Our Ref: 40263

Your Ref: DC/25/0629

**Submission of additional information and responses to consultee comments for planning application ref. DC/25/0629  
– Former Novartis Site, Parsonage Road, Horsham, West Sussex**

*Figure 1. Extract of Design and Access Statement showing the Current Planning Application and proposed North-West elevation.*

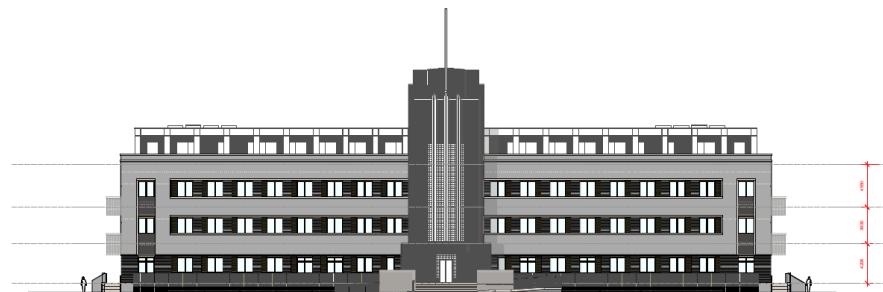
Since the original submission, detailed structural investigations have identified significant deficiencies in the structural integrity of *Building 3*. A Structural Report has been prepared that explains the findings of these investigations, which finds that there are wide ranging challenges associated with structural instability and non-compliance with current standards. With reference to the submitted structural report, in summary the challenges include corroded wall ties, external brickwork cracking, water ingress, and basement degradation.

The consequence of these structural deficiencies is that the 'wings' of *Building 3* cannot reasonably be converted. These parts of the building require replacement.

This amended scheme is therefore to retain and convert the central clock tower in line with the original proposals, and to replace the 'wings' of the building with high-quality and architecturally sympathetic replacement buildings of an equivalent footprint and size. The same number of new homes would be provided within these parts of the building as was proposed in the original application.
